December 4, 2003

LICENSEE: Union Electric Company

FACILITY: Callaway Plant

SUBJECT: SUMMARY OF MEETING WITH UNION ELECTRIC COMPANY ON
NOVEMBER 12, 2003, TO DISCUSS TWO LICENSEE APPLICATIONS AND
POTENTIAL INSTRUMENTATION DIGITAL UPGRADES AT THE PLANT (TAC
NOS. MB9875, MB9876, AND MB9879)

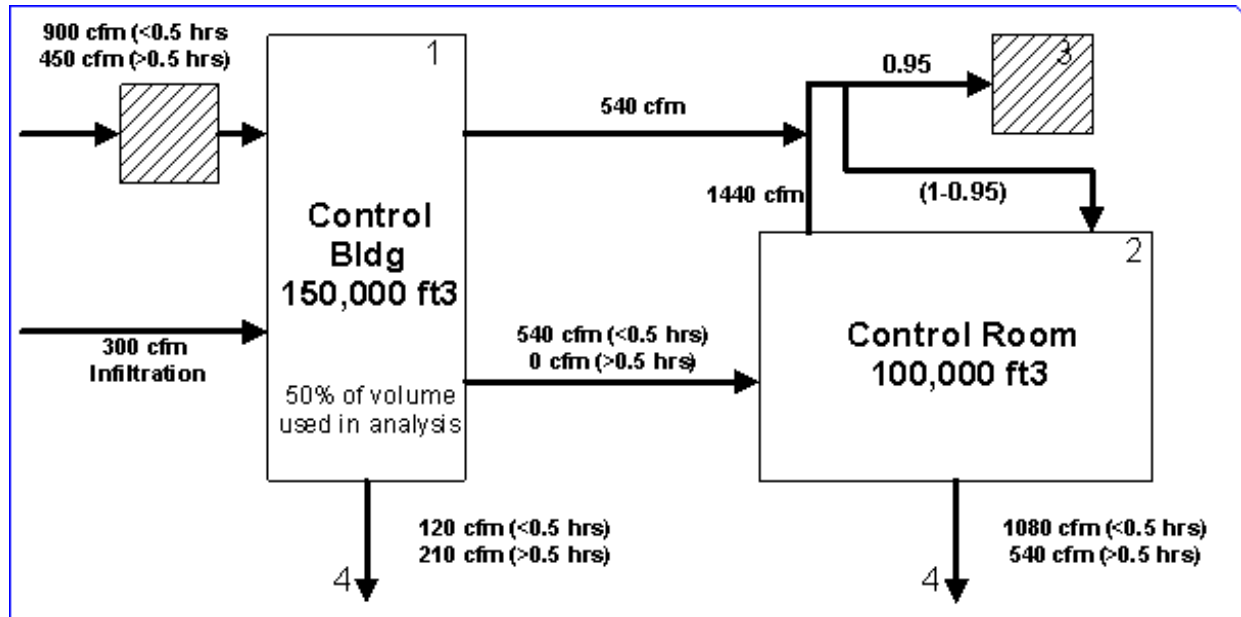
The figure below represents the staff's interpretation of appropriate modeling of your control building and control room. Node 3 is the recirculation filter; node 4 is a "sink." Discuss the staff's interpretation and confirm if the staff's understanding is correct. In particular, discuss if the expected re-alignment will occur at 30 minutes for this event and provide the basis for this conclusion.

The staff's flow diagram does not match the one used by AmerenUE. The following diagram is taken from Section 15A of the Callaway FSAR:

The diagram has two flow paths not shown on the staff's diagram. The first is direct inleakage from the environment to the Control Room. The second represents Control Room outleakage returning to the Control Building.
